Seat belt wet, SRS light on

Topic number	LI91.40-N-056663
Version	1
Design group	91.40 Seat belts, emergency tensioning retractors
Date	07-23-2013
Validity	Model 906 with CODE (T16) Right load compartment sliding door and/or with CODE (T19) Left load compartment sliding door
Reason for change	
Reason for block

1.jpg:

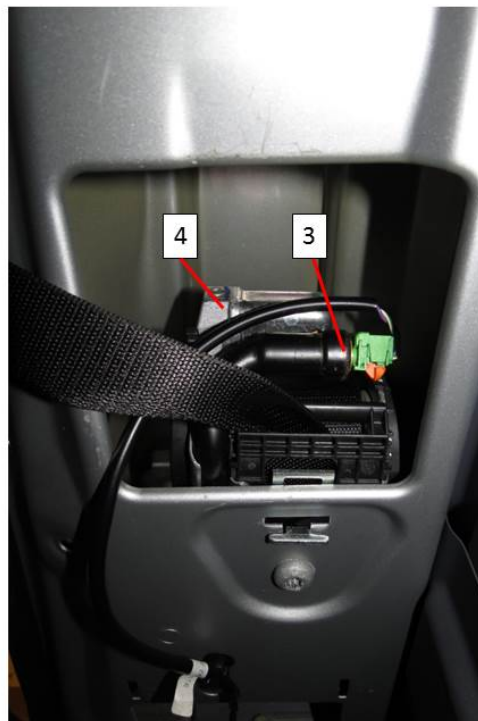
Water ingress at the B-pillar (sliding door side), which can cause contact problems in the connector of the emergency tensioning retractor.

3. Install cover (File 1, item 1 or 2) for emergency tensioning retractor (File 2, item 4).

Installing a cover on the opening in the B-pillar (inside) prevents water from entering the electrical connection of the emergency tensioning retractor.

The cover(s) are only to be installed on the side of the vehicle with the sliding door.

Parts							
Part number	ES1	ES2	Designation	Quantity	Note	EPC	Other make part
A 906 691 00 00			Cover	1	Cover (1) for left B-pillar. For vehicles with code (T19) Left load compartment sliding door.	X	
A 906 691 01 00			Cover	1	Cover (2) for right B-pillar. For vehicles with code (T16) Right load compartment sliding door.	X
